City of Carlisle, Iowa  
Planning and Zoning Commission  
Regular Meeting  
March 15, 2021  
7:00 P.M.  
Carlisle City Hall

RE: **Danamere Farms Plat 10 – Construction Plan Review**  
**Carlisle, Iowa**  
*FOX Ref No: 8666-03C.259*

FOX Engineering has completed the second review for of the Danamere Farms Plat 10 (formerly Danamere Plat 9) Construction Plans, dated March 10, 2021 and offer the following comments:

# DANAMERE PLAT 10 CONSTRUCTION DRAWINGS

LIGHTING PLAN

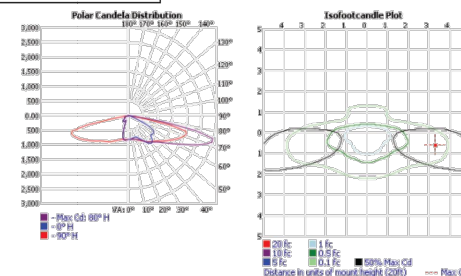
### **Sheet 19 – Lighting Plan**

26. Please provide dimensions between light poles.

**LANDSCAPE PLAN**

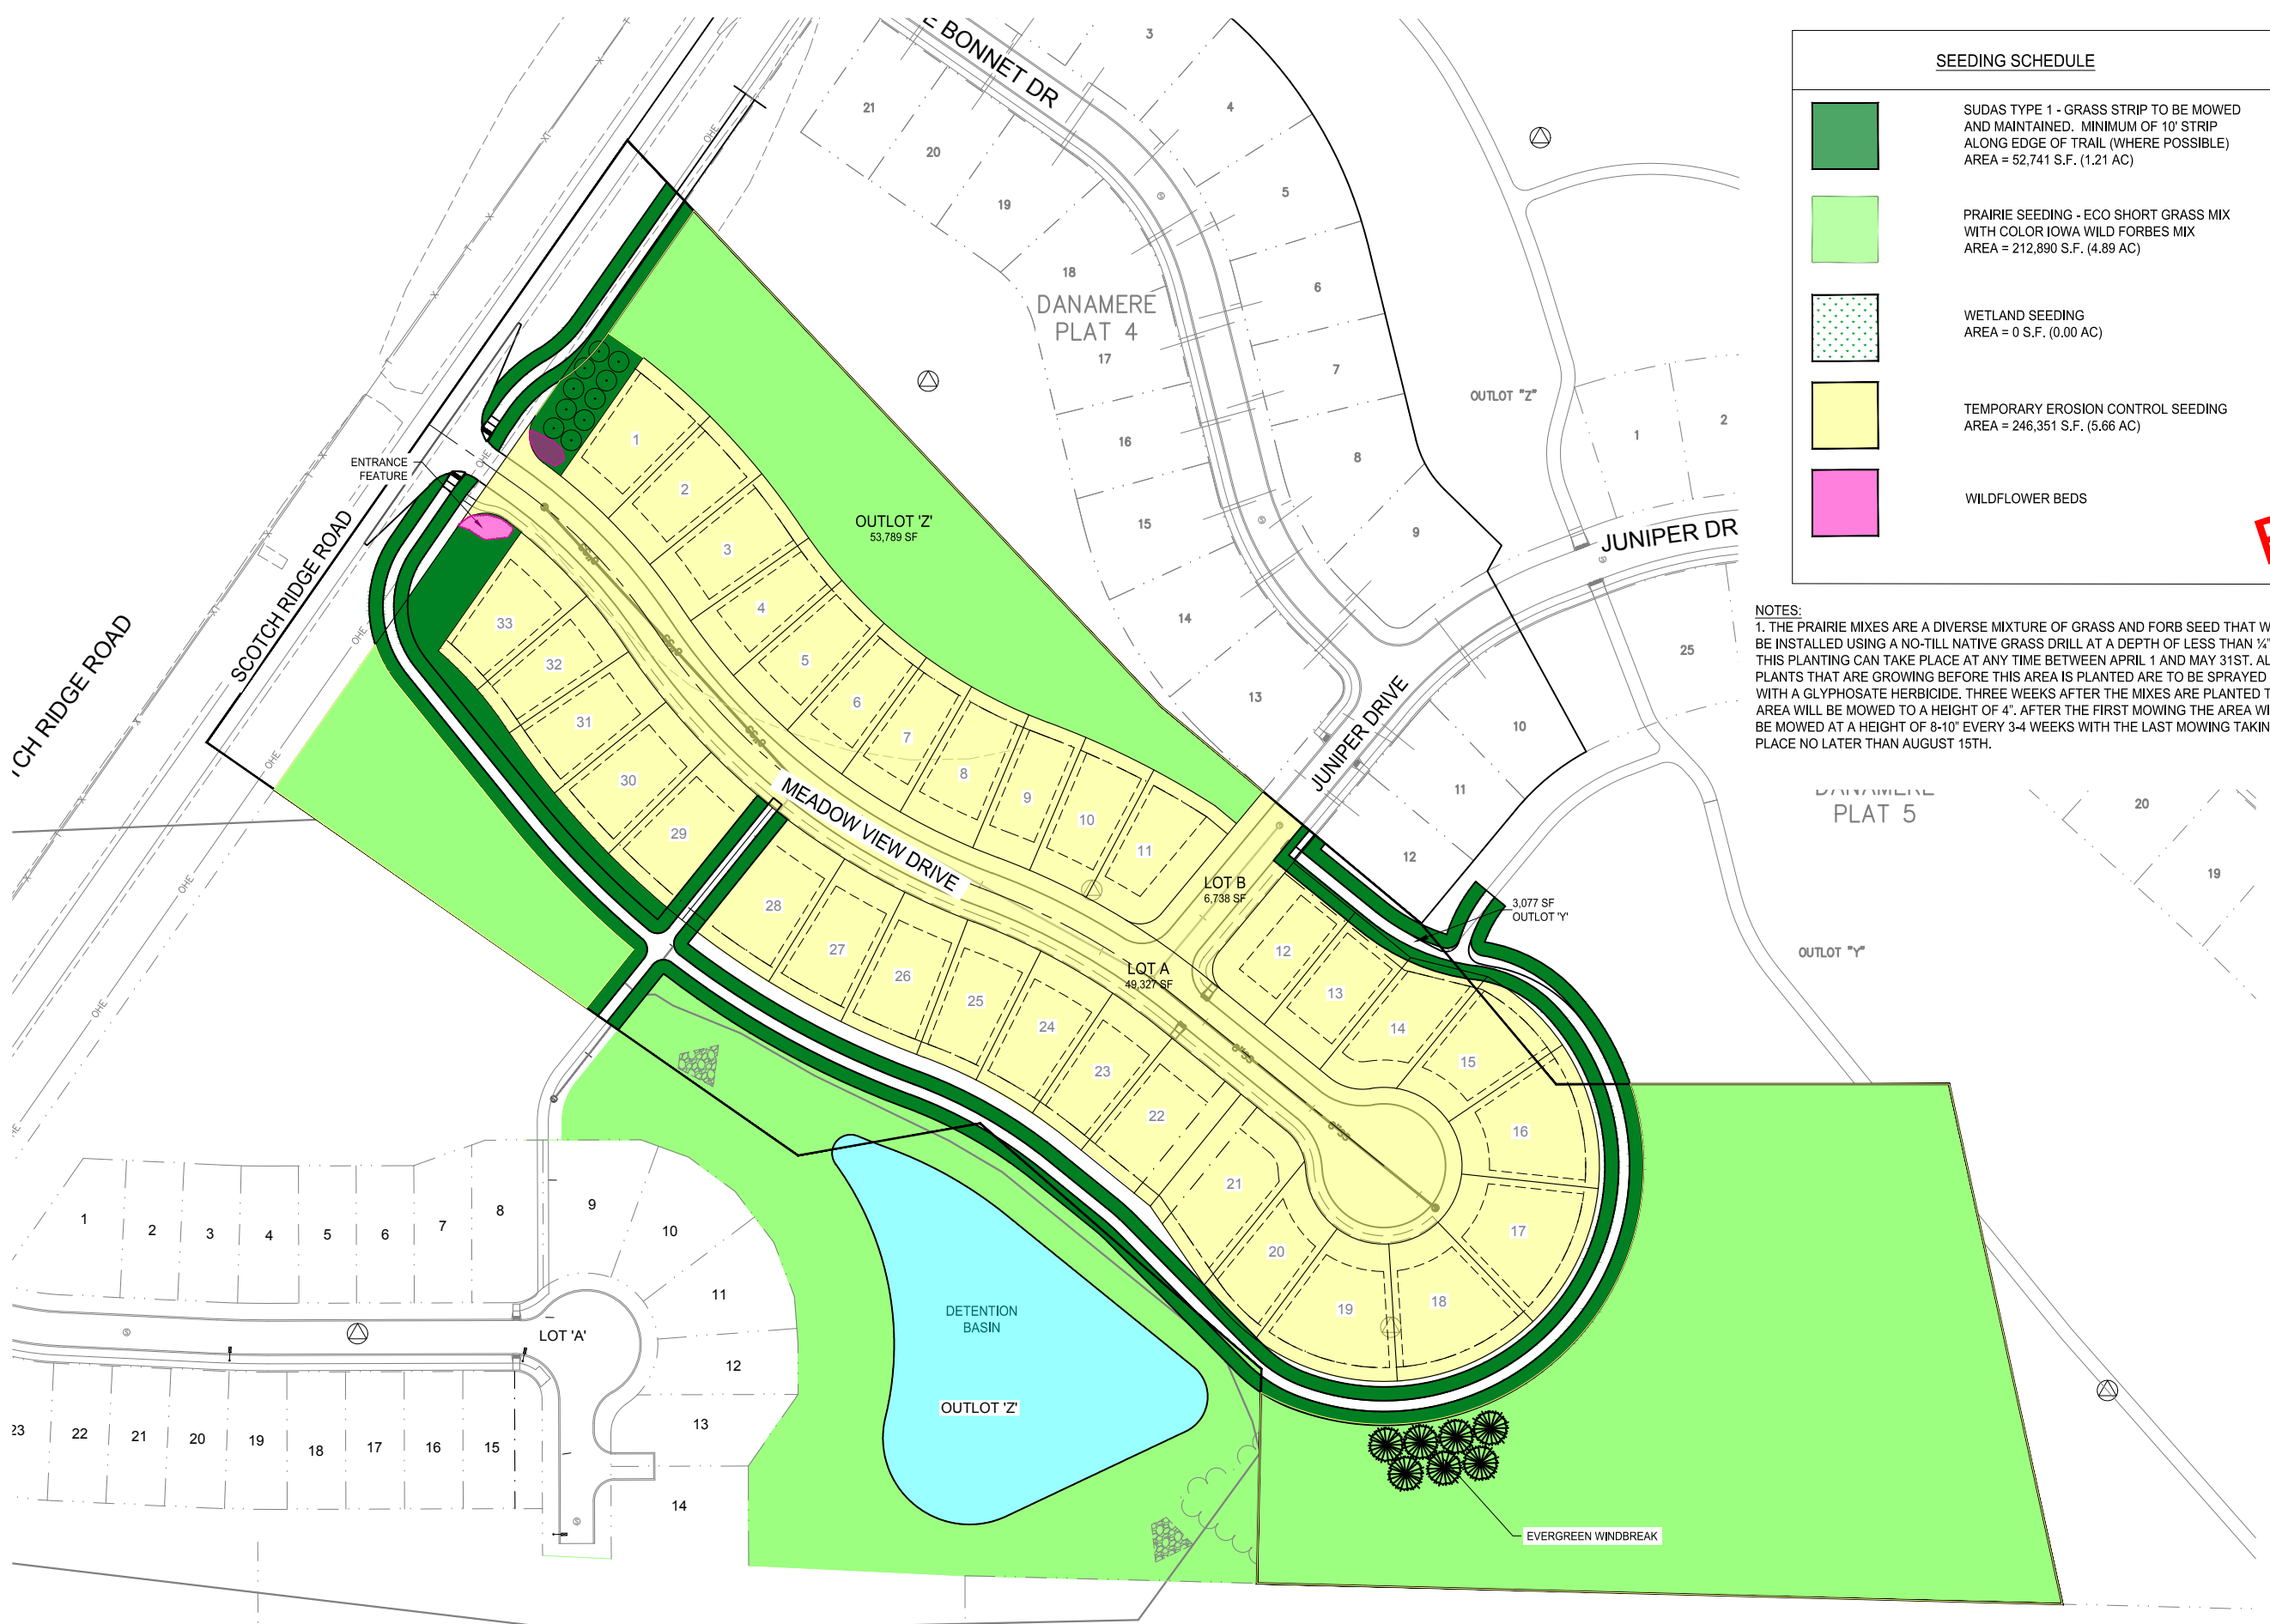
### **Landscape Plan**

28. Please provide detail for type/spacing/number for the evergreen windbreak. Also, please provide information regarding what the entrance feature will look like. Will there be a monument sign at this access to Danamere?

9 4" SLOPED CURB DETAIL  
NOT TO SCALE

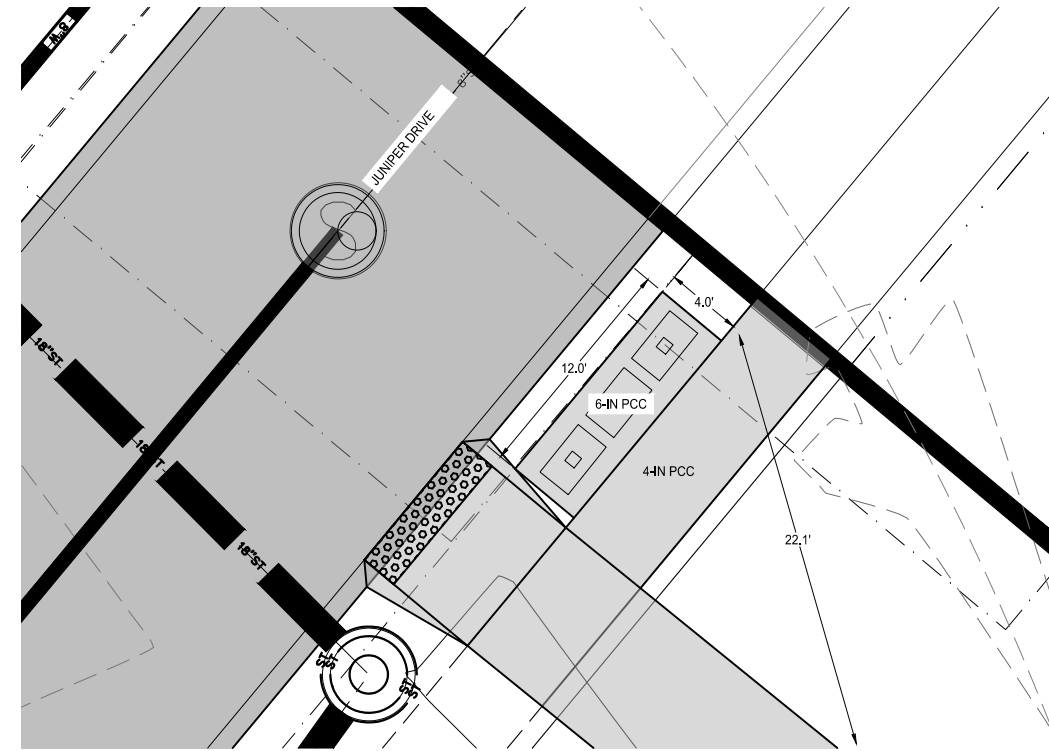
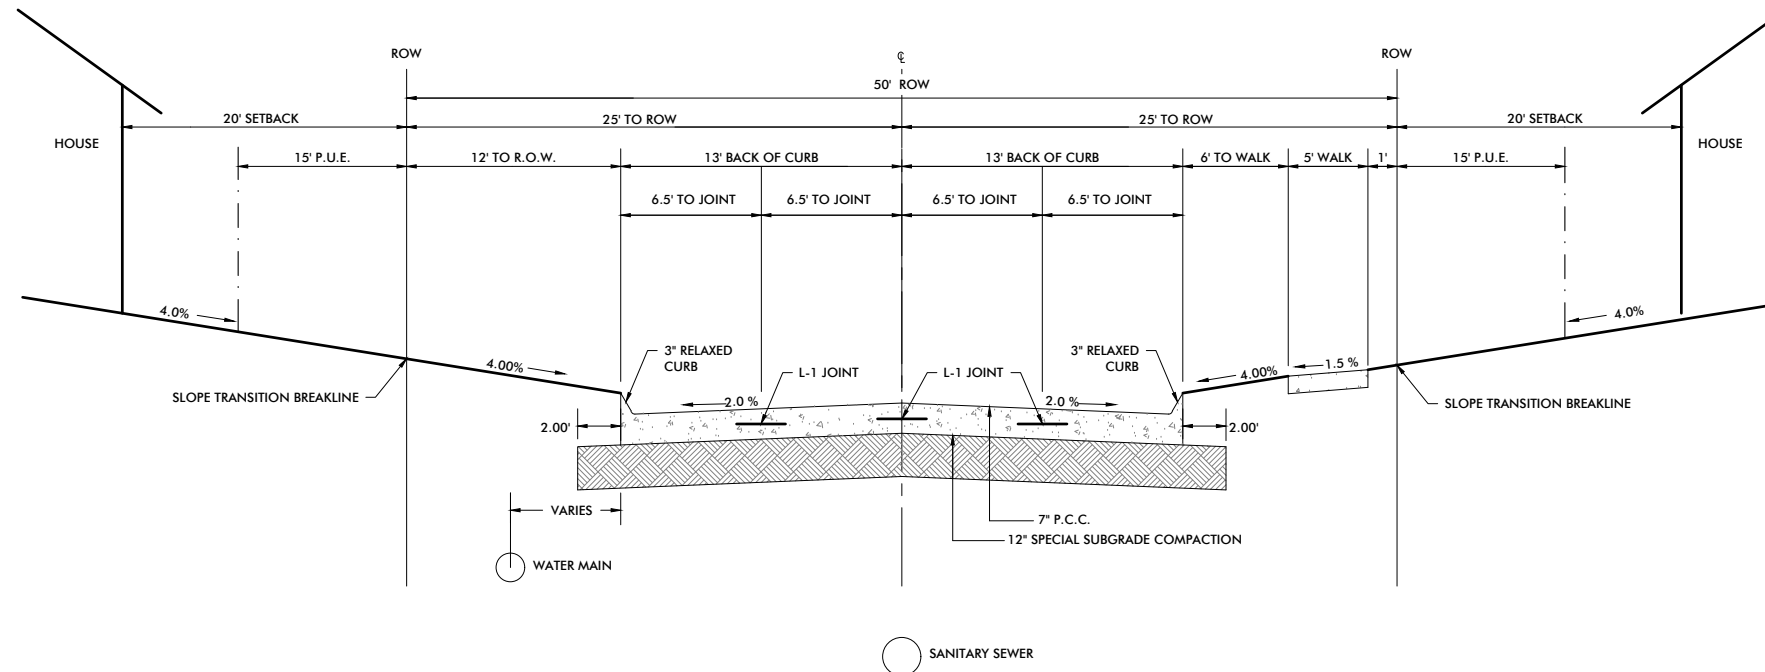
### **Sheet 21 – Details**

27. Please review the curb details. The typical section indicates a 3" relaxed curb, the other detail on this sheet indicates a 4" sloped curb. Plat 4 plans showed a 3" sloped curb.
